STAFF RECOMMENDATION
910 Waldkirch Avenue
August 16, 2017

Application: New construction – infill and outbuilding
District: Waverly-Belmont Neighborhood Conservation Zoning Overlay
Council District: 07
Map and Parcel Number: 10513035600
Applicant: Emily Johns
Project Lead: Paul Hoffman, paul.hoffman@nashville.gov

<p>Description of Project: Construction of a one-and-a-half story residence and outbuilding.</p> <p>Recommendation Summary: Staff recommends approval of the application with the conditions:</p> <ol style="list-style-type: none">1. The finished floor height shall be consistent with the finished floor heights of the adjacent historic houses, to be verified by MHZC staff in the field;2. Staff has final approval of the masonry, windows and doors, rear porch posts and railing, and roof color;3. The HVAC shall be located behind the house or on either side, beyond the mid-point of the house. <p>Staff finds that the application meets Section III for New Construction in the Waverly-Belmont Neighborhood Conservation Zoning Overlay.</p>	<p>Attachments A: Photographs B: Site Plan C: Elevations</p>
---	--

SITE PLAN
 OF
910 WALDKIRCH AVE., NASHVILLE, TENNESSEE
LOT 50, OF WALDKIRCH'S SUBDIVISION
 PLAT BOOK 421, PAGE 90, R.O.D.C., TN.
 SEVENTENTH CIVIL DISTRICT, DAVIDSON COUNTY

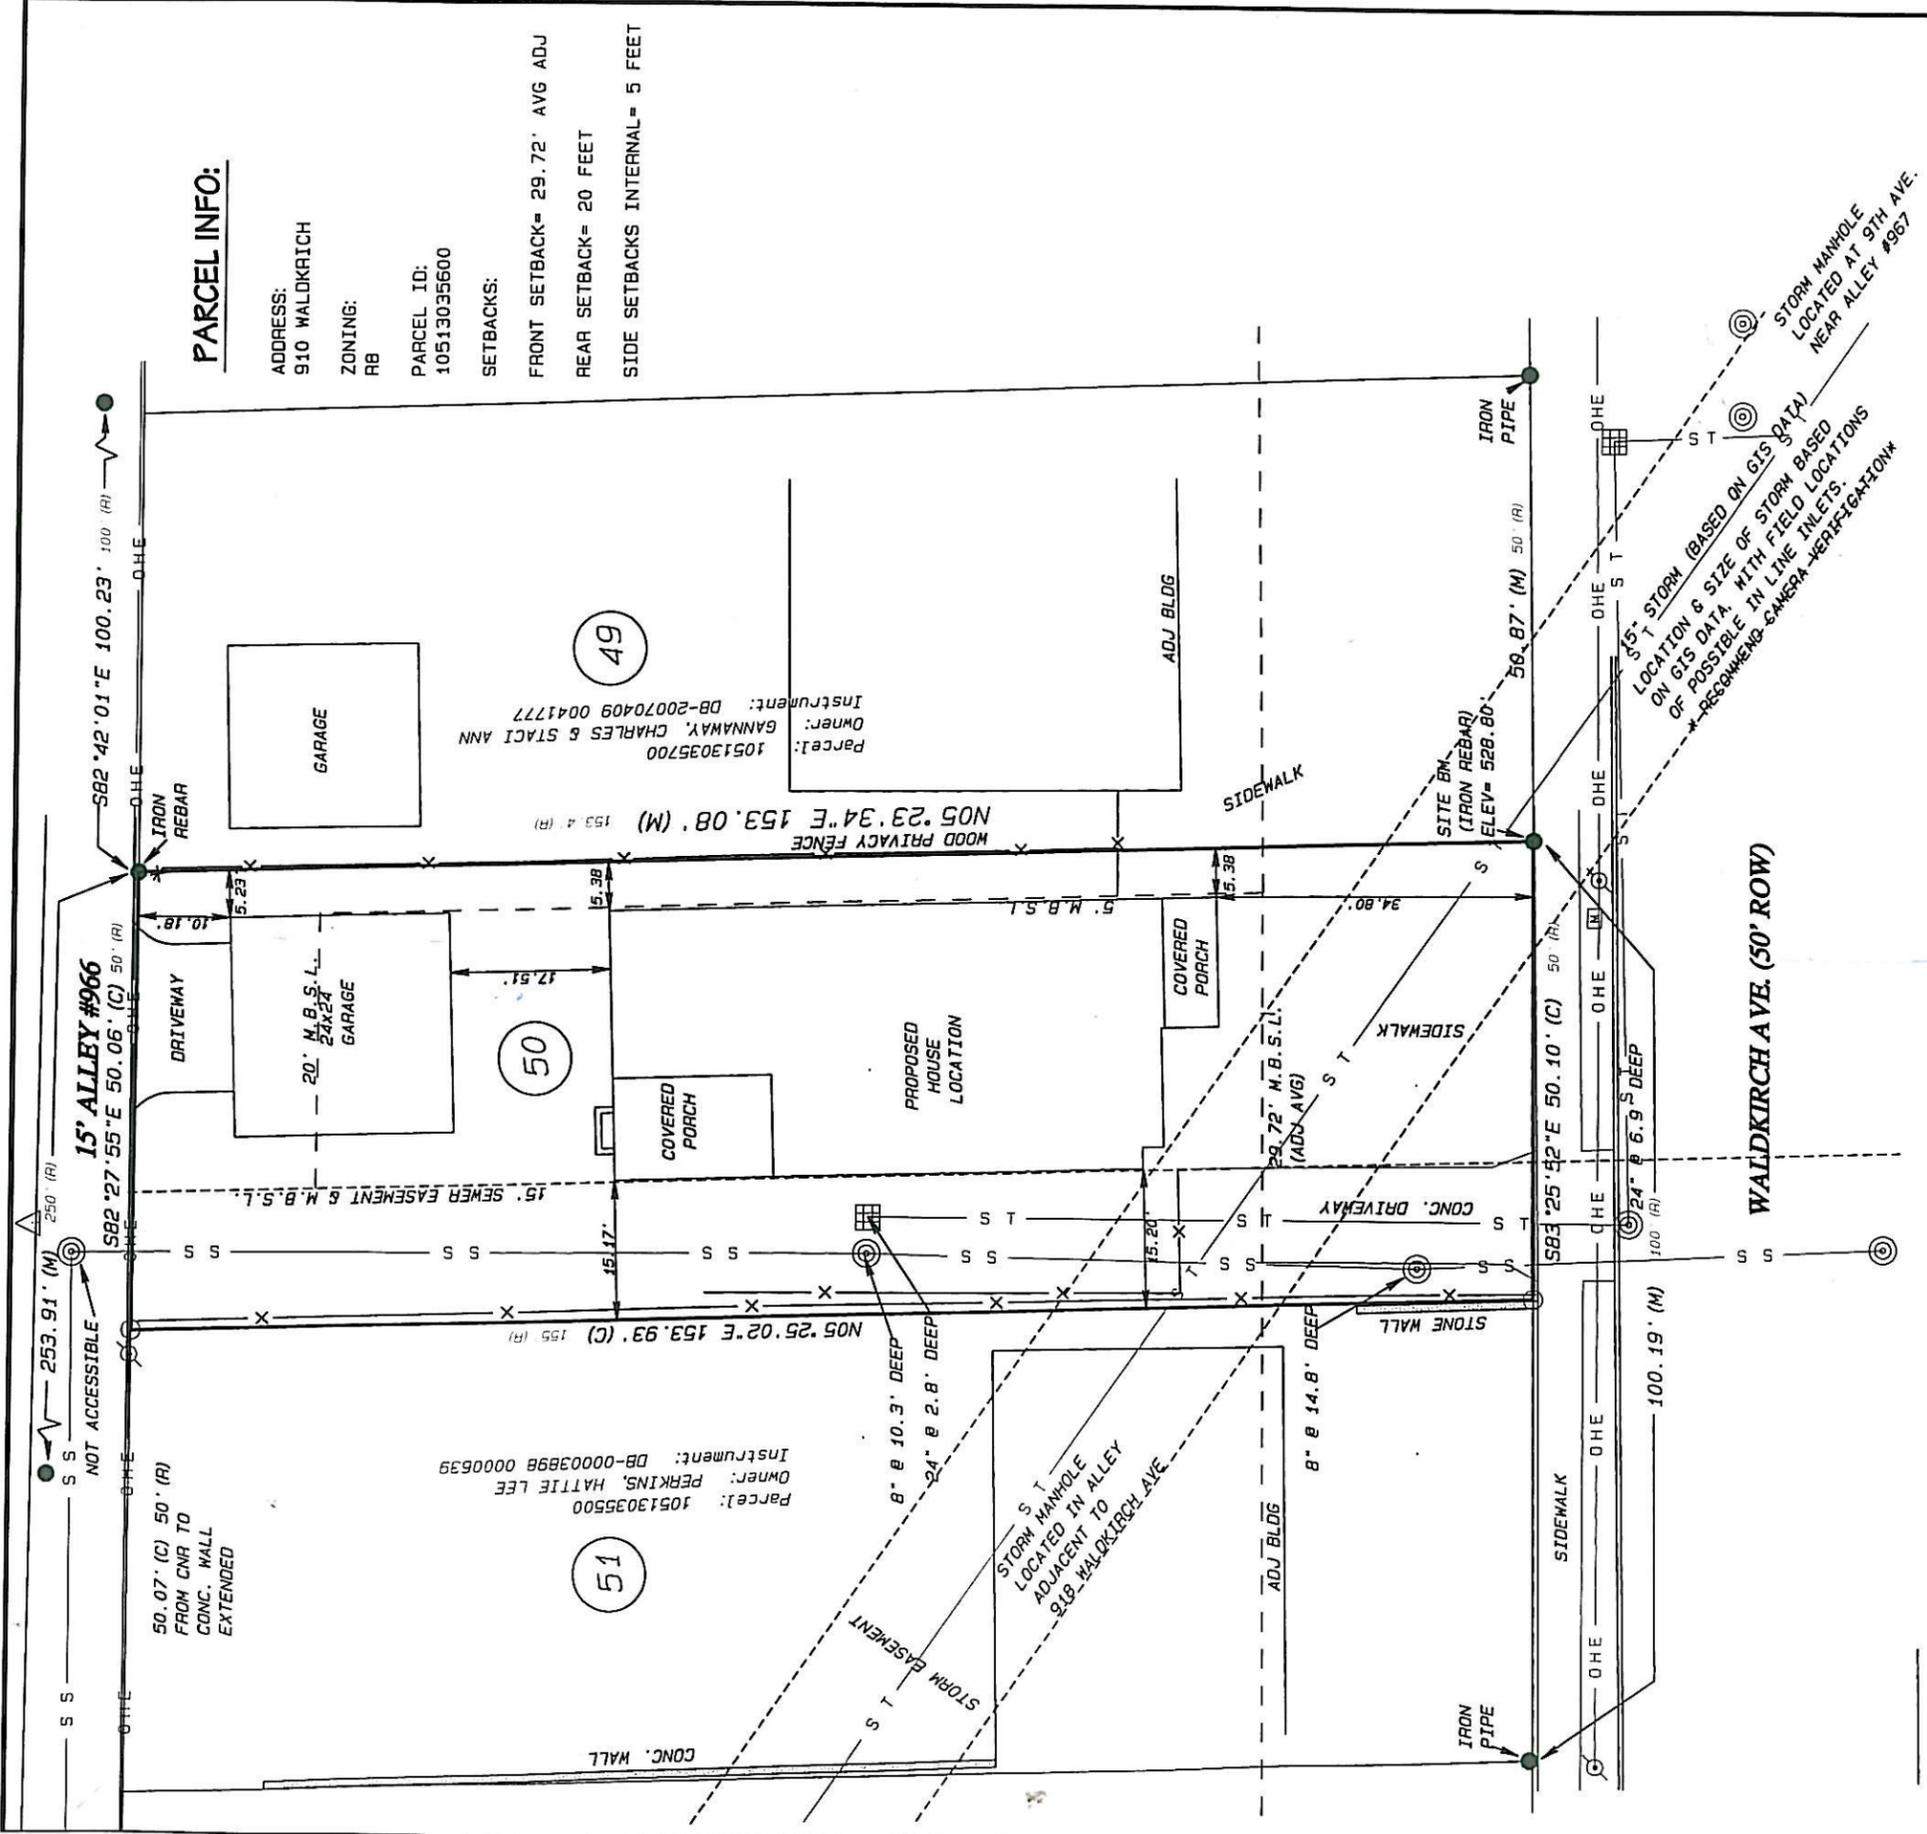
Setback & Rhythm of Spacing: The proposed new building meets all base zoning setbacks. It will be five feet, four inches (5' 4") from the right side property line, approximately fifteen feet (15') from the left side property line, and fifty feet (50') from the rear property line. These dimensions meet the required five feet (5') on the sides and twenty feet (20') setbacks at the rear. The house is not centered on the wide lot. Staff finds this to be appropriate because the two easements necessitate that the proposed front and side setbacks. Staff therefore finds that the house's placement on the lot will not adversely affect the rhythm of spacing along the street.

The house's front porch will be approximately thirty-five feet (35') from the front property line. The neighboring contributing building is twenty-six feet (26') from its front property line. However, the easement running across the front of the subject lot restricts the ability to build any closer to the front property line. The off-center porch design brings the building forward, to the extent possible, with the angled easement. Therefore Staff finds the front setback to be appropriate, and the infill's setback and rhythm of spacing to meet Section III.C of the design guidelines.

*The design guidelines state that there should be a minimum of twenty feet (20') in between a primary structure and an outbuilding. As the infill is required to be located farther back on the lot, Staff finds that eighteen feet (18') between the structures is appropriate, due to the reduced buildable area on the lot.

FRONT ELEVATION

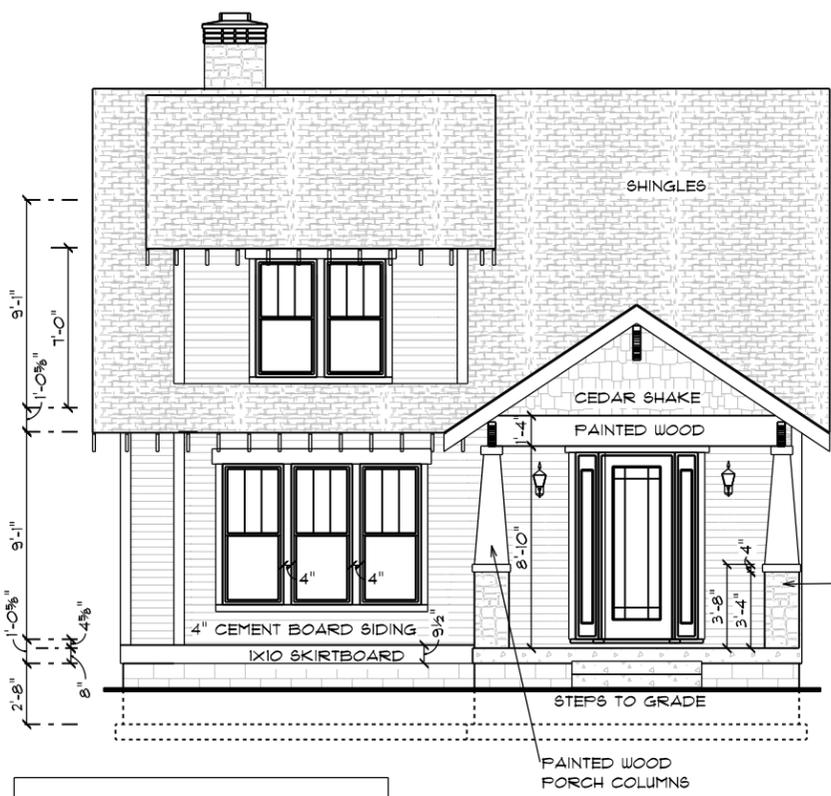
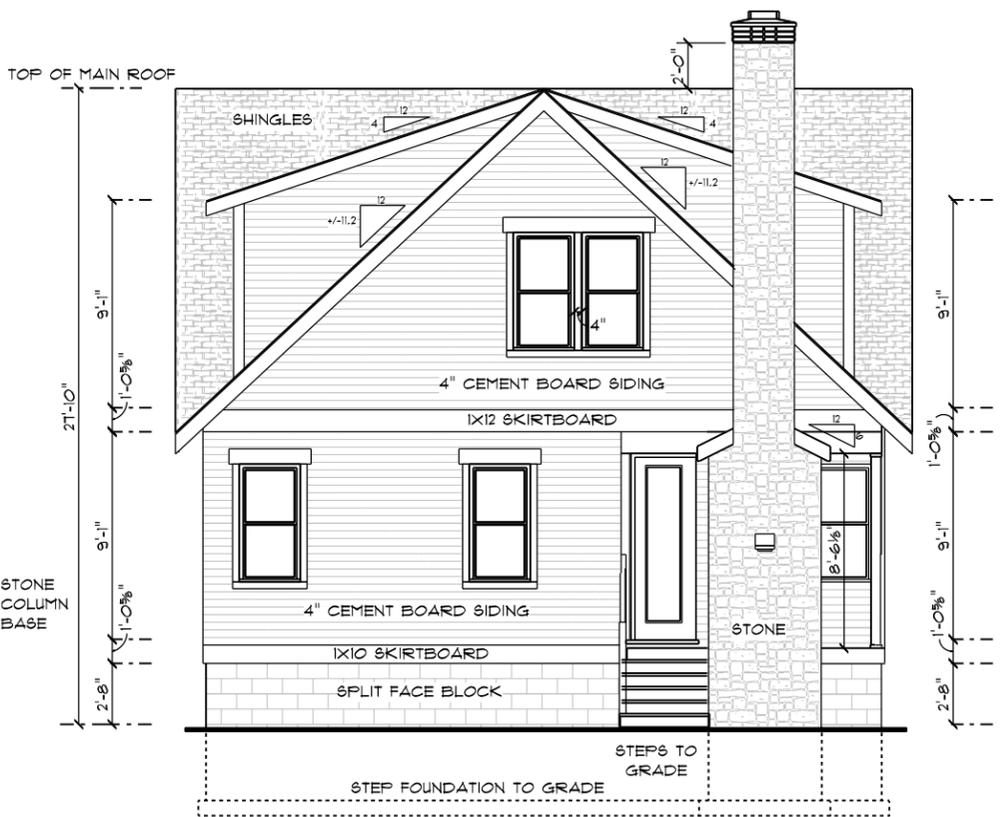
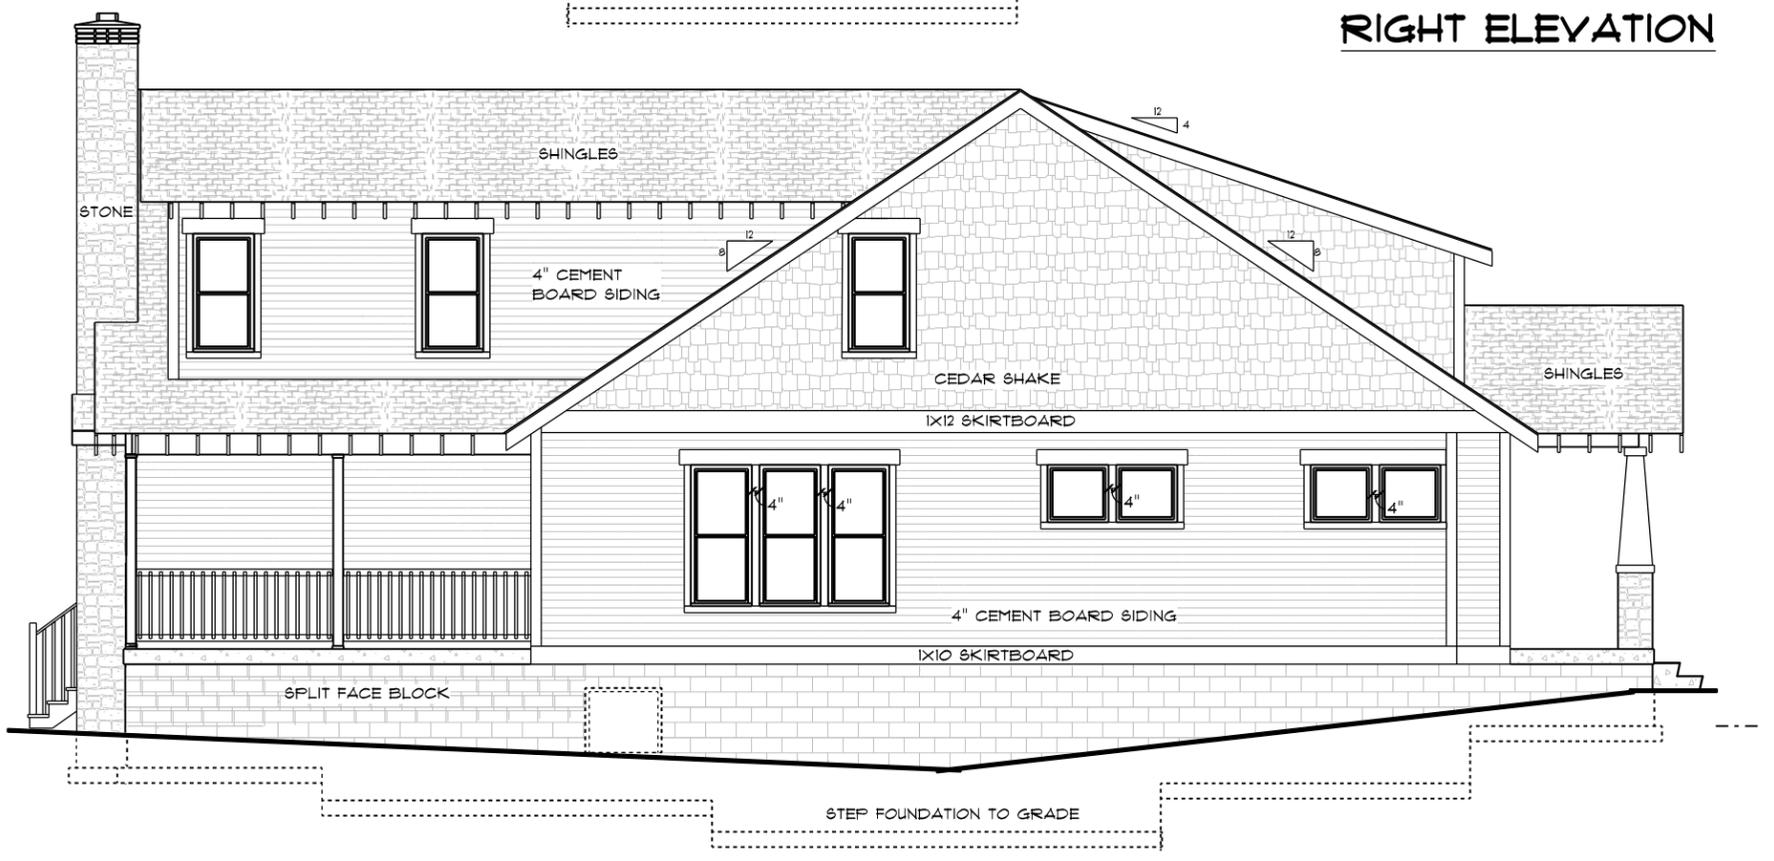
Height & Scale: The proposed house is one-and-a-half stories, with a ridge height of twenty-seven feet, ten inches (27' 10") from grade. Staff finds that this meets the historic context, where the houses are largely one and one-and-a-half stories with maximum heights ranging from nineteen feet to thirty feet (19'-30'). The foundation height will be approximately eighteen inches (18") at the front; the lot dips from front to back, so the foundation height will increase to between four and five feet (4'-5') in the middle of the structure. The foundation height is within the height of the contributing buildings nearby,

which are from one foot (1') to five feet (5'). The eave height will be approximately eleven feet (11') from grade, which is also within the range of historic buildings nearby, which are from nine feet (9') to twelve feet (12') in height.

Roof form: The primary roof form is a side gable with a shed dormer on the front façade. The primary gable will have a slope of 8/12. The rear section of the house will have shed dormers with 4/12 pitch and are set back from the wall below by two feet (2'). Staff finds that the proposed roof form meets Section III.E for roof form and pitch.

Proportion and Rhythm of Openings: The windows on the new structure are generally twice as tall as they are wide, meeting the historic proportion of openings. There are no

large expanses of wall space without a window or door opening. A horizontal transom style window on the right elevation is at the rear end of that side, so Staff finds it appropriate in that location. Staff finds the project’s proportion and rhythm of openings to meet Section III.G. of the design guidelines.

RIGHT ELEVATION

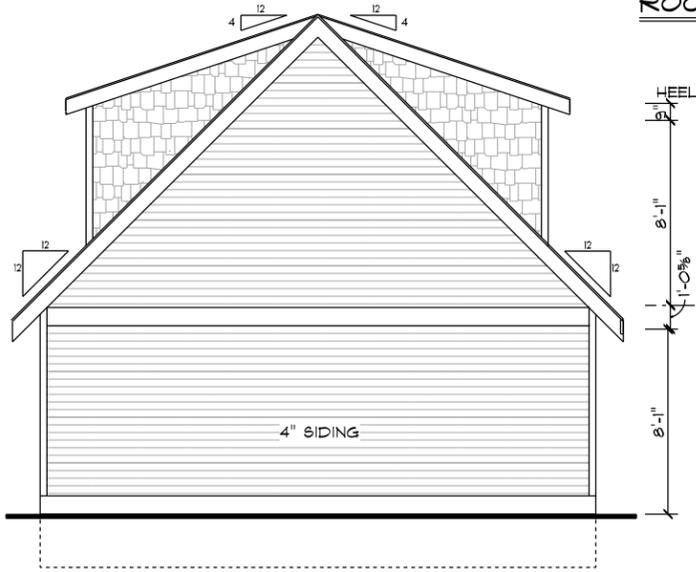
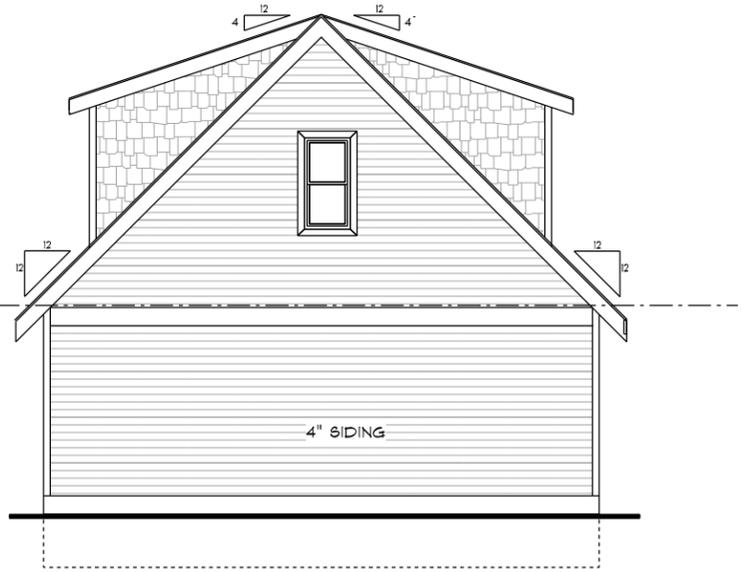
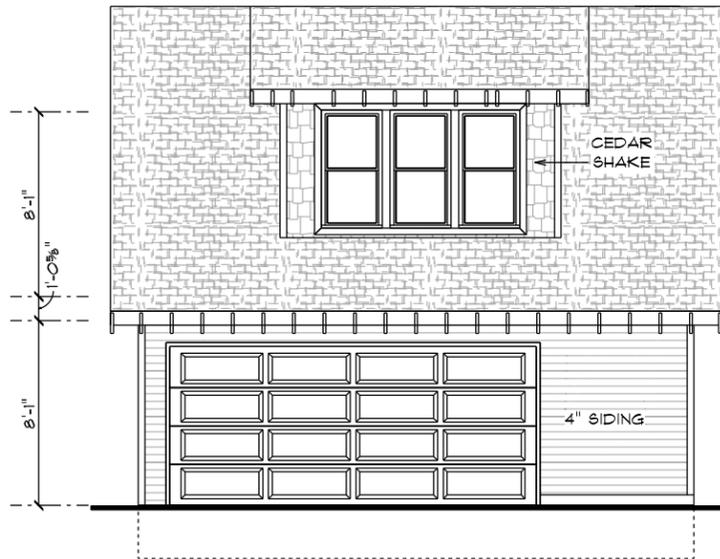
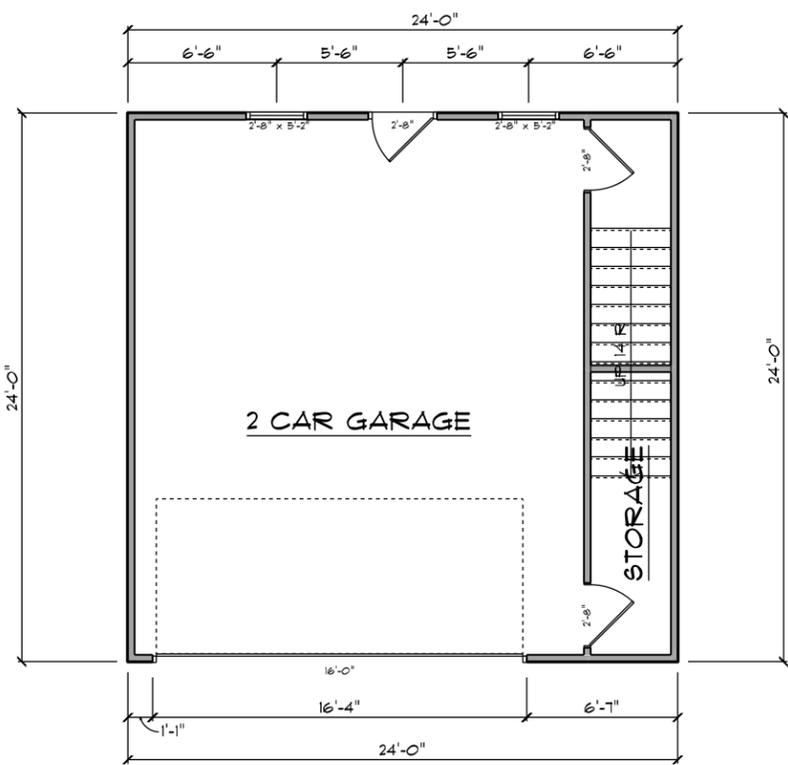
Potential maximums	Existing conditions (height of historic portion of the home to be measured from finished floor)	Proposed
Outbuilding Ridge Height	25’	27’ 10”	21’
Outbuilding Eave Height	10’	11’	8’

Proposed Element	Proposed Form	Typical of district?
Outbuilding primary form	Side Gable	Yes
Primary roof pitch	12/12	Yes
Dormer Form	Shed	Yes
Dormer pitch	4/12	Yes

Staff finds that the proposed roof forms for the outbuilding meet Sections III.H.1 and III.H.3 of the design guidelines.

With the staff's final approval of the windows, doors, garage doors and the color of roofing, staff finds that the known materials meet Section III.H of the design guidelines.
